KMR.CDD.CiQ.1921-1922.01

RE: BUILDING ON PLOT NO. 2-B, F-7 CIVIL LINES QUARTERS.

RE: AMENDED PLANS FOR THE PROPOSED BUILDING ON PLOT NO. 2-B, F-7
CIVIL LINES QUARTERS.

PROPOSED BUILDING

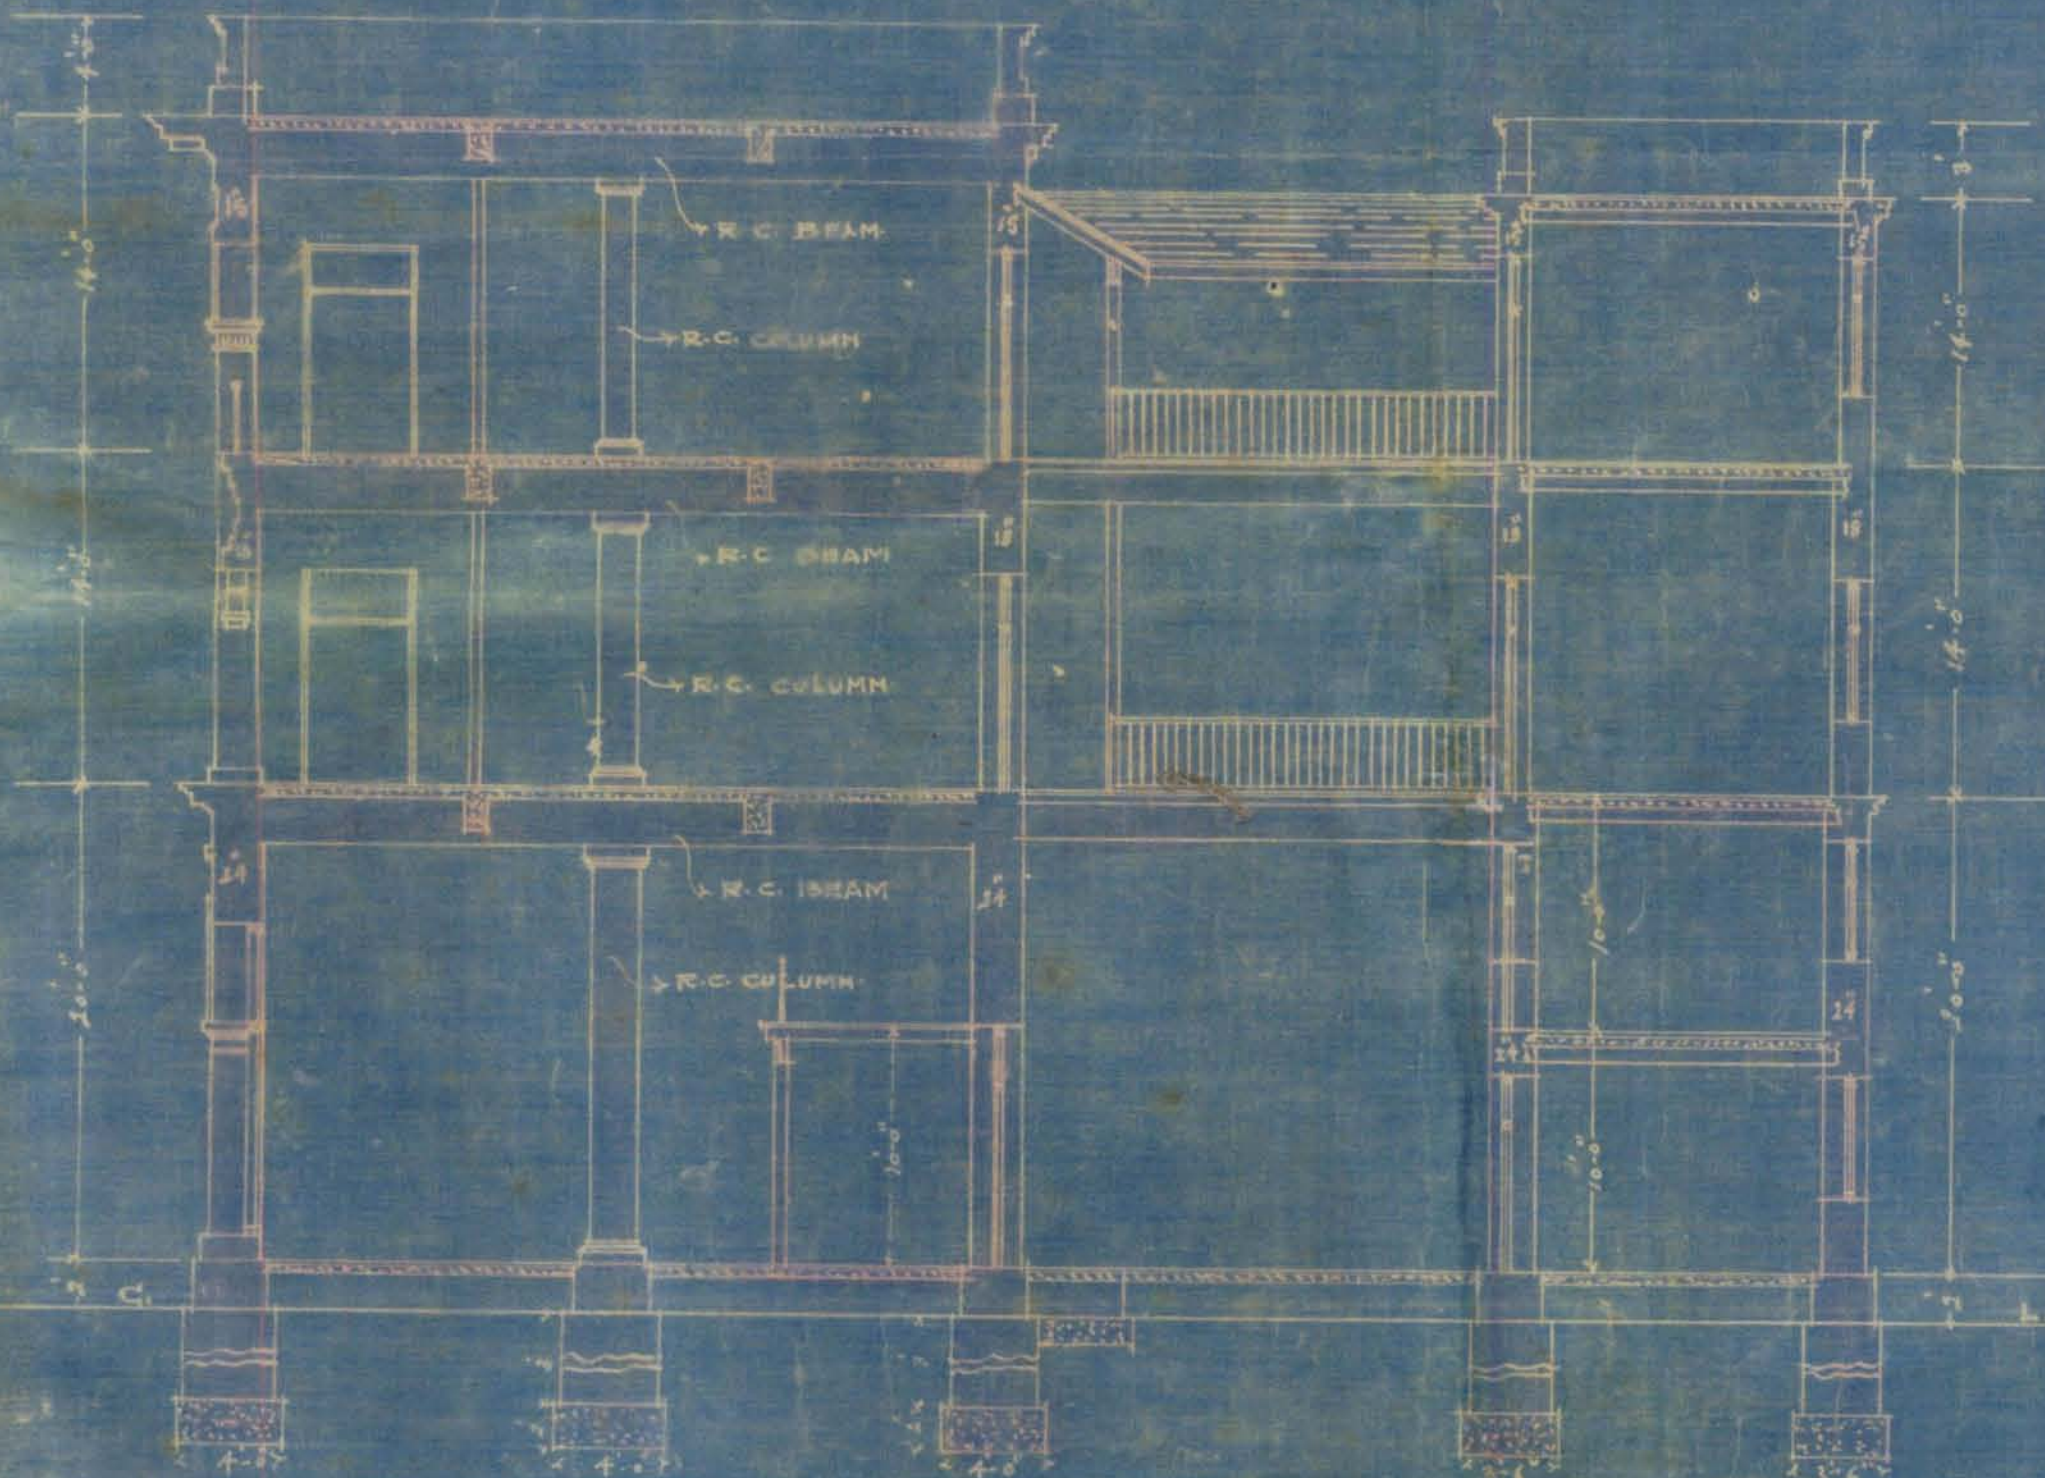
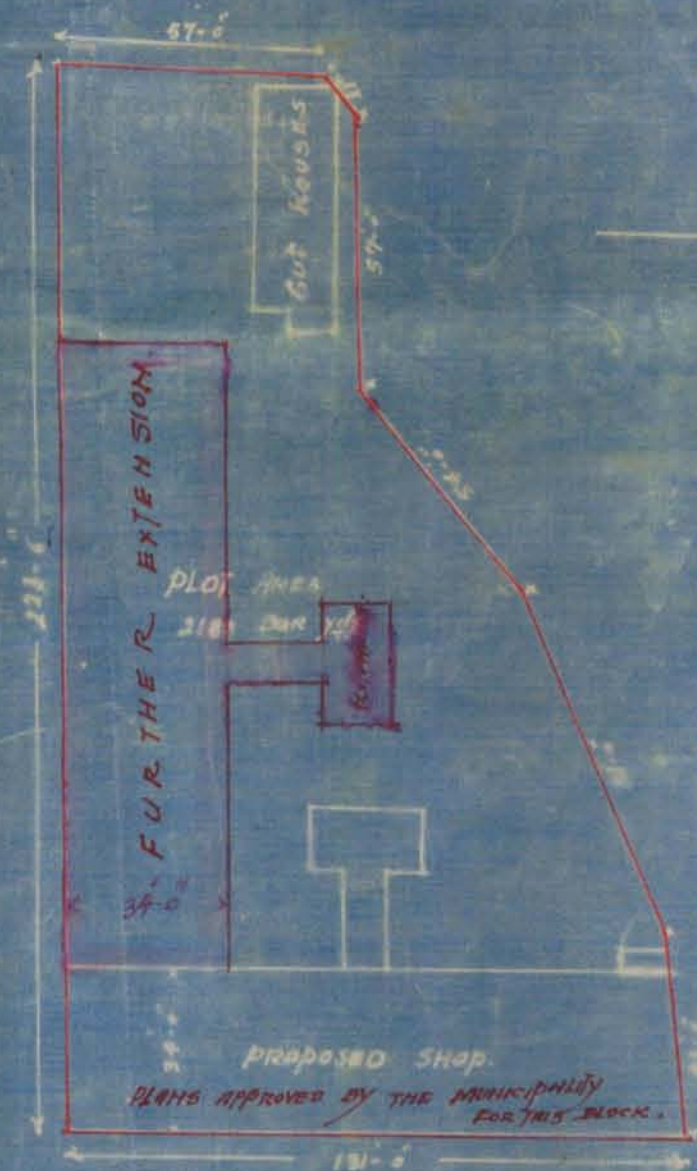
With reference to your letter no. L.S. 519 dated 27th January, 1922, we have the honour to send you herewith two more copies of the front elevation drawing, one of which, is on linen.

Undersigned has the honour to inform Khan Bahadr K. A. Katrak that the amended plan of the proposed building on plot No. 2-B, F-7 Civil Lines Quarter has been approved by this Office & the City Deputy Collector. Two more copies of ~~xxxx~~ the front elevation drawing one of which should be on linen, should be submitted, when a pass to start the work can be issued.

SET OF APPROVED PLAN

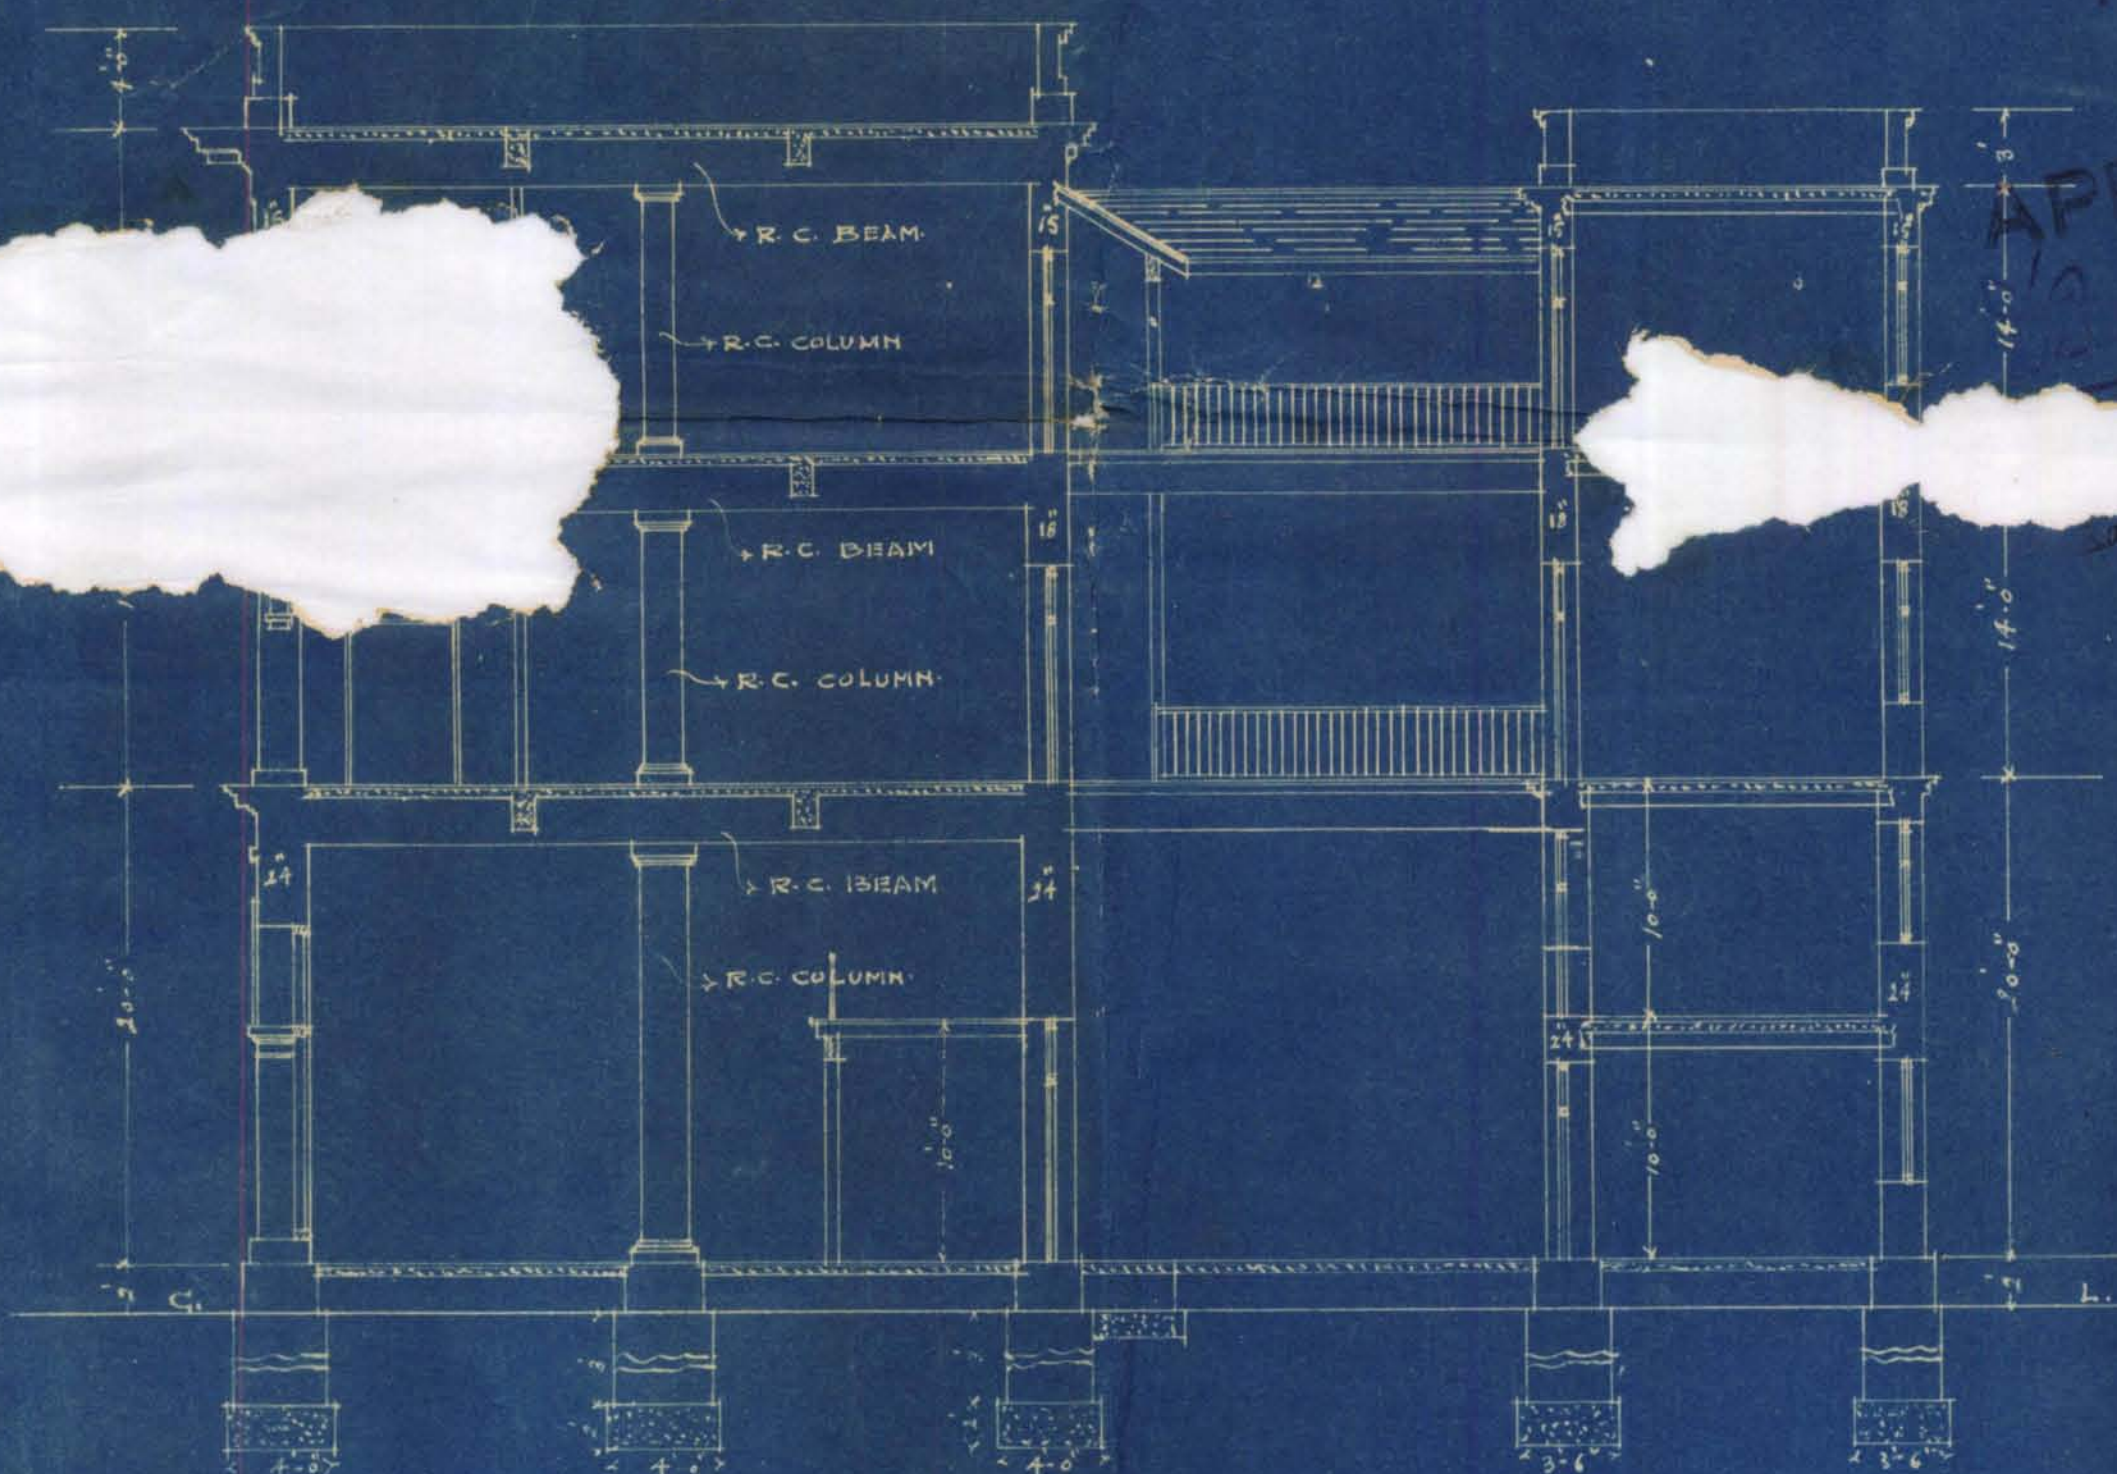
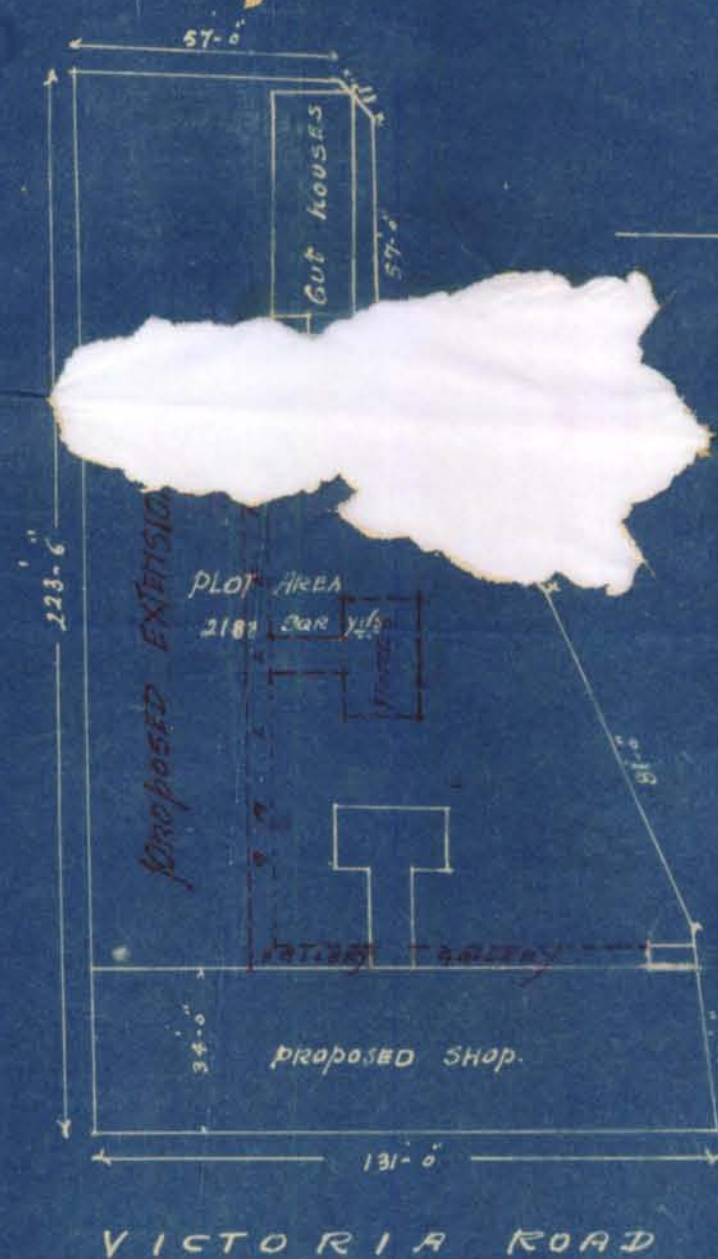
(1) That the plans for the building, which have been already approved by your office no. L.S. 3047 dated 23rd June, 1921, cover almost $\frac{1}{3}$ the area of the whole plot.

(2) That from the above Memo, I am to understand that I can not extend the building any more and the whole portion marked X X Y Z Z, on the site plan showing the whole surroundings, to remain vacant and to serve absolutely no purpose.

(3) That the plans for the further extensions are rejected not on their merits or demerits or any sanitary grounds but only because the building area to be covered exceeds $\frac{1}{3}$ the area of the whole plot.

In this respect, I may be allowed to point out that there are no such conditions stipulated in the sanad, nor do I know of any such rules or regulations in the Municipal Bye-laws. Besides from the accompanying site plan of the whole surroundings, you will find that there are number of buildings erected only a few years back, have been allowed to be built upon over much more than $\frac{1}{3}$ the area of the plots, not only that, but the
